SERVICE BULLETIN REVISION TRANSMITTAL SHEET

MODEL BD-100-1A10 (CH-350)

Service Bulletin No. 350-76-002

MODIFICATION – ENGINE CONTROLS – UNCONTROLLABLE HIGH THRUST – EASA RETRO-FIT

K1000070347 – Kit – UHT Relays and Grounds Installation
 (Sheet 1 of 1, Rev. A)

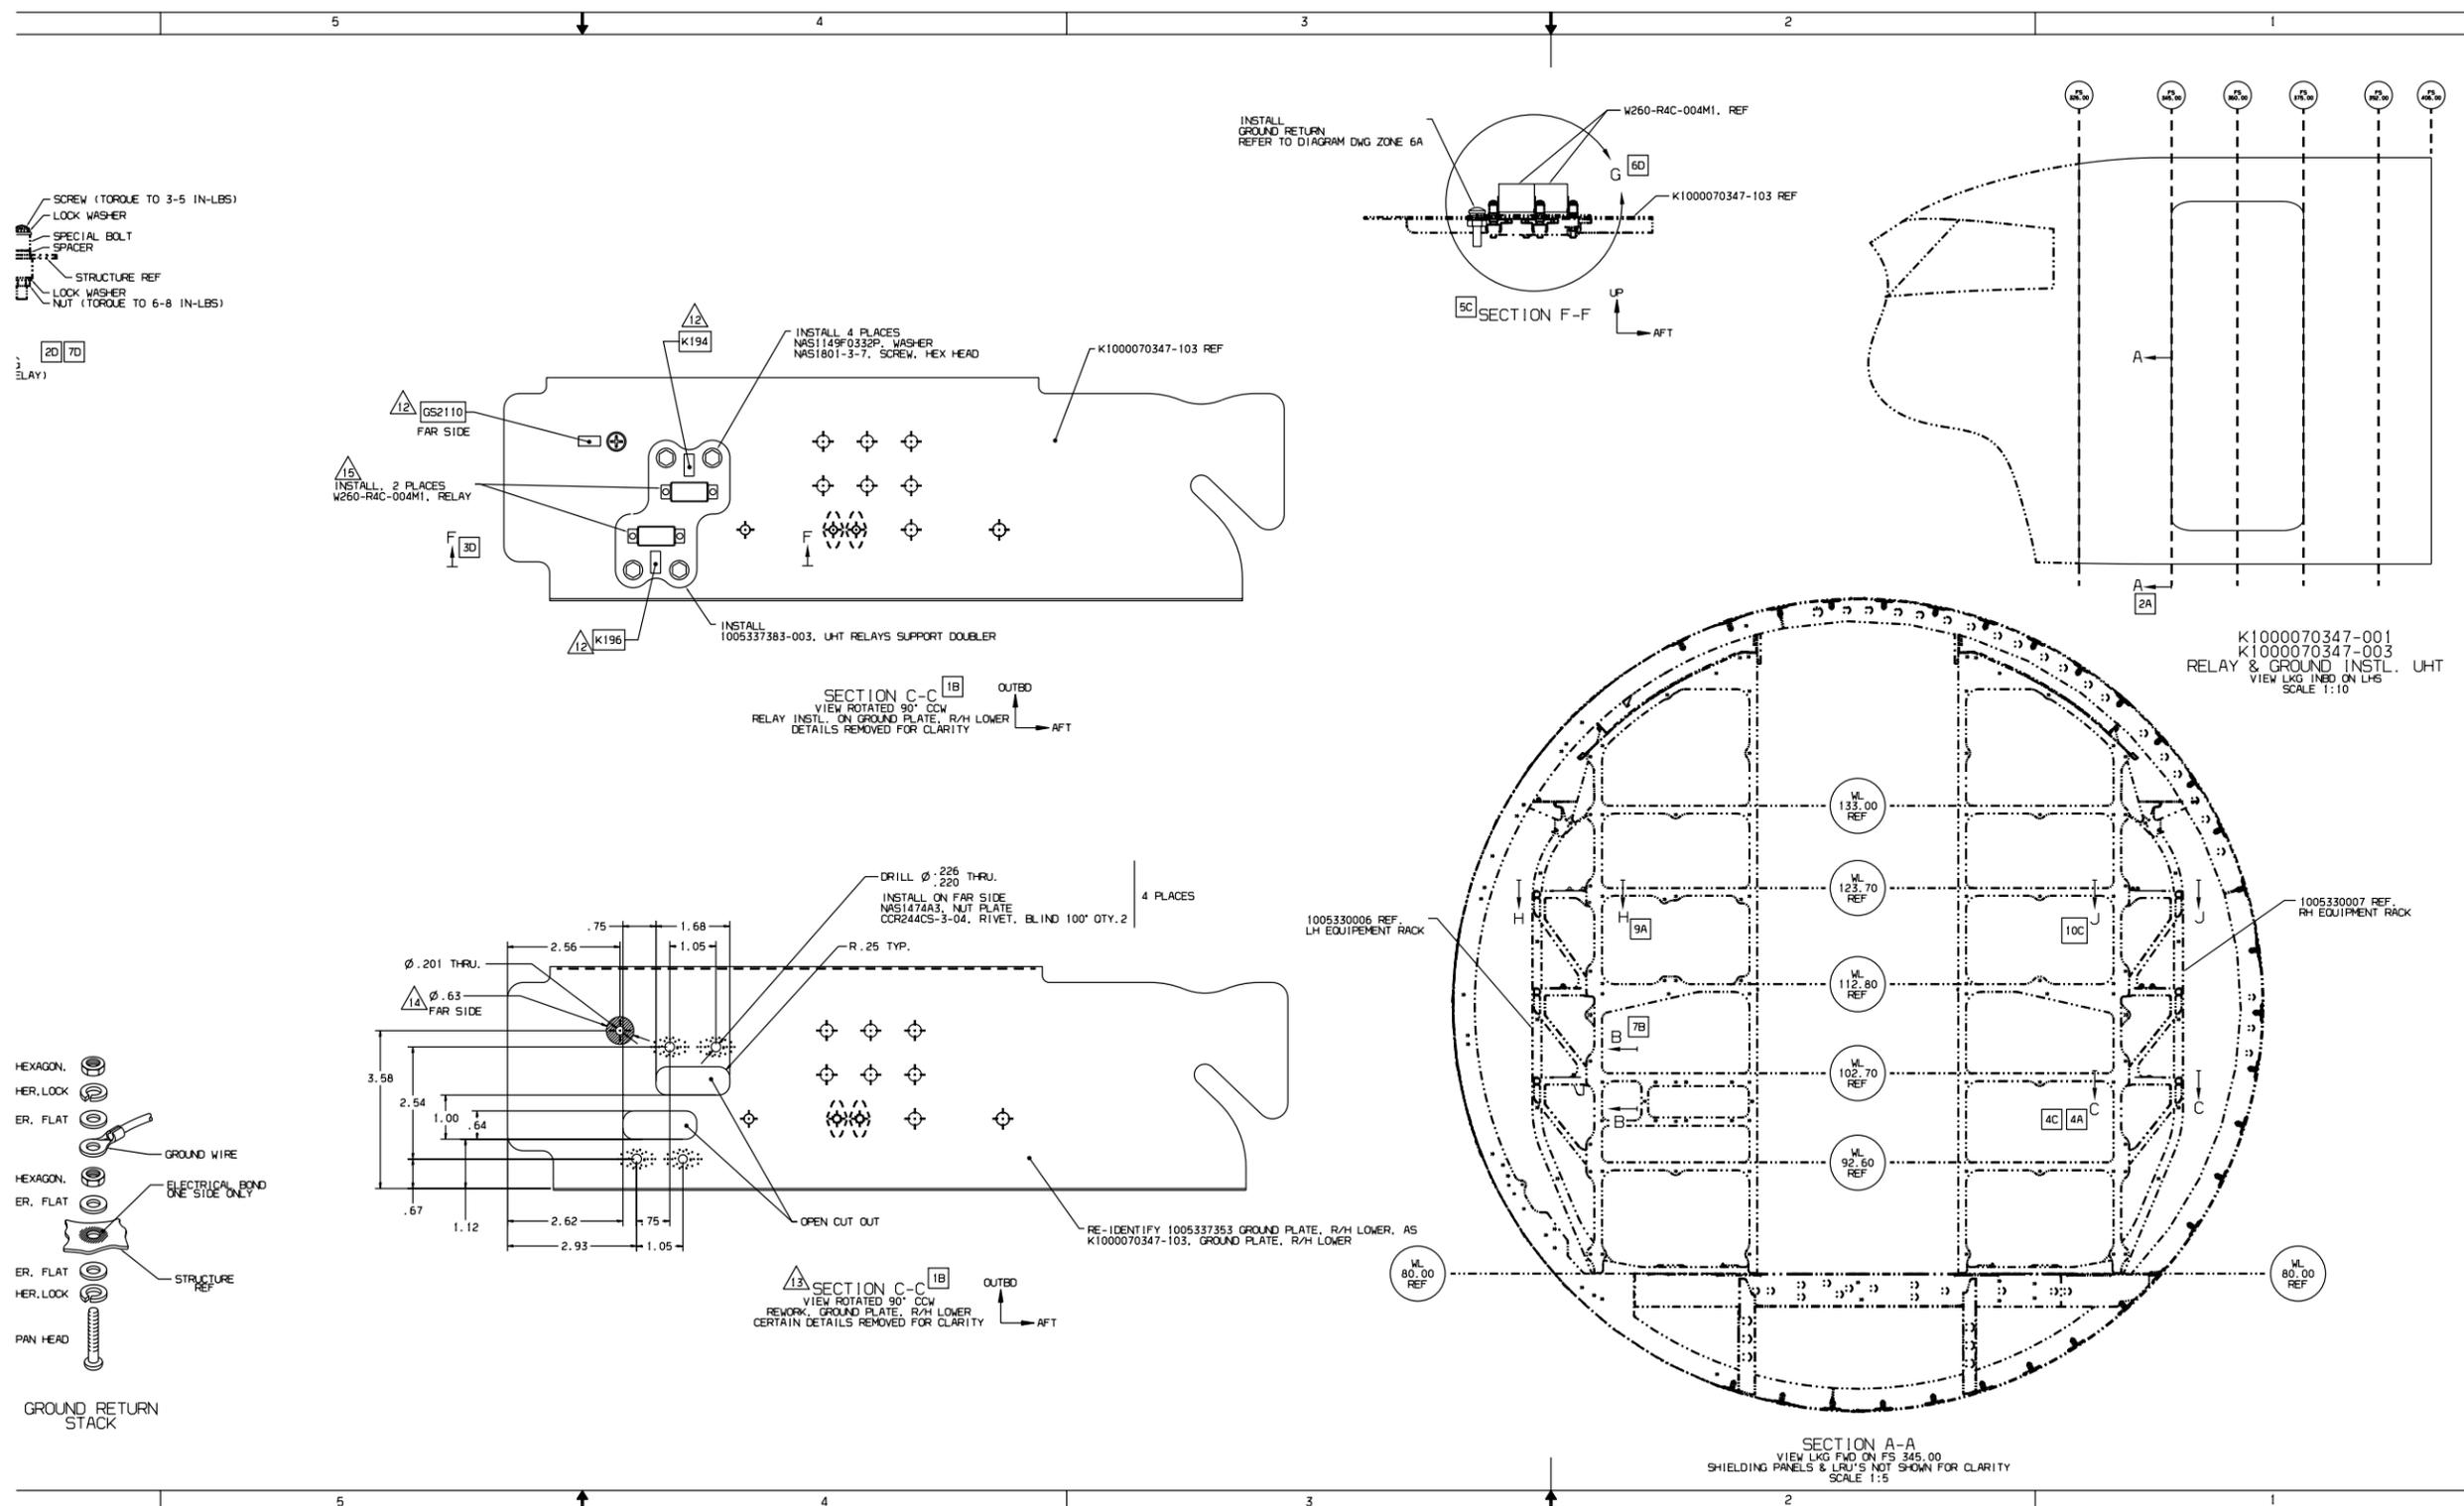
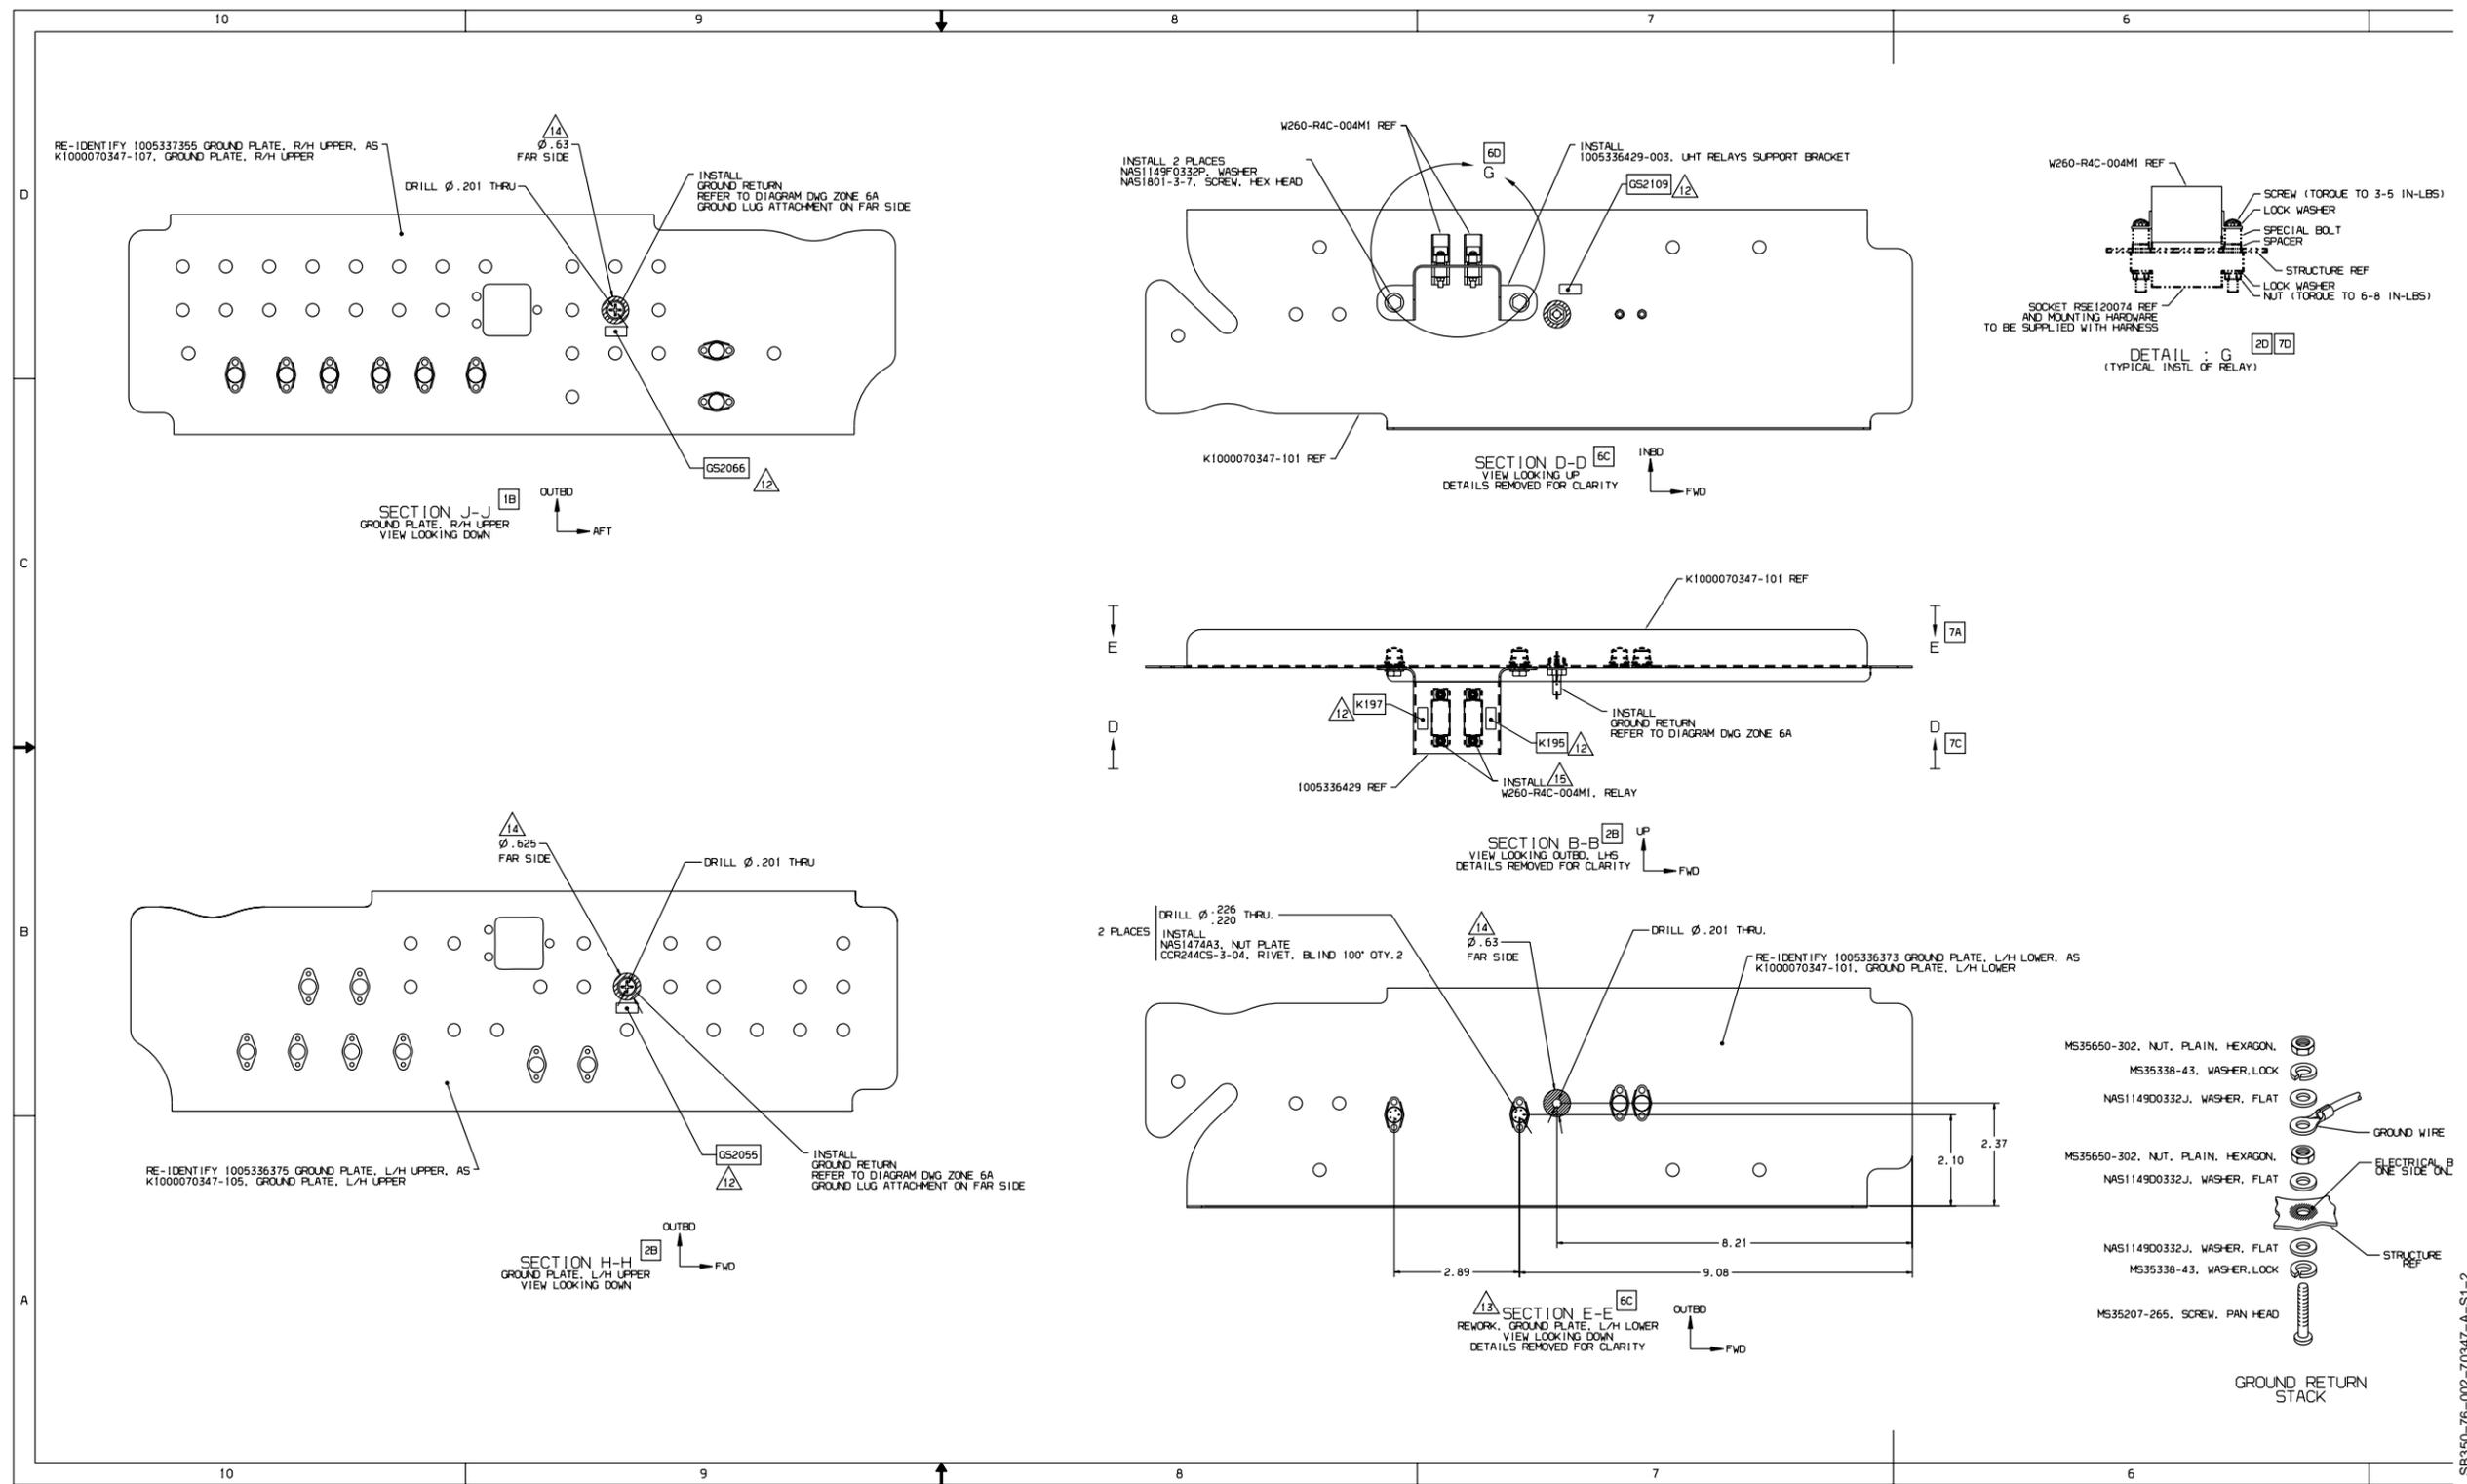
- (1) Install UHT relay brackets, relays and grounds per installation K1000070347-001 in the L/H and R/H avionics racks. Refer to Kit Drawing K1000070347.

- (1) Install UHT relays and electrical identifications per installation K1000070347-003 in the L/H and R/H avionics racks. Refer to Kit Drawing K1000070347.
- (2) Do the UHT wiring modification as per **PART E** of this Service Bulletin.
- (3) Update the ECU software/replace ECU as instructed in Honeywell Service Bulletin AS907-76-9026.
- (4) Replace the W6 harness as instructed in Honeywell Service Bulletin AS907-76-9028.
- (5) Load the Maintenance Diagnostic Tables (MDT-3110) Part No. 810-0042-273 to the Maintenance Diagnostic Computer (MDC-4110). Refer to AMM 45-45-01-970-803.
- (6) Remove the tags and close the circuit breakers that follow:
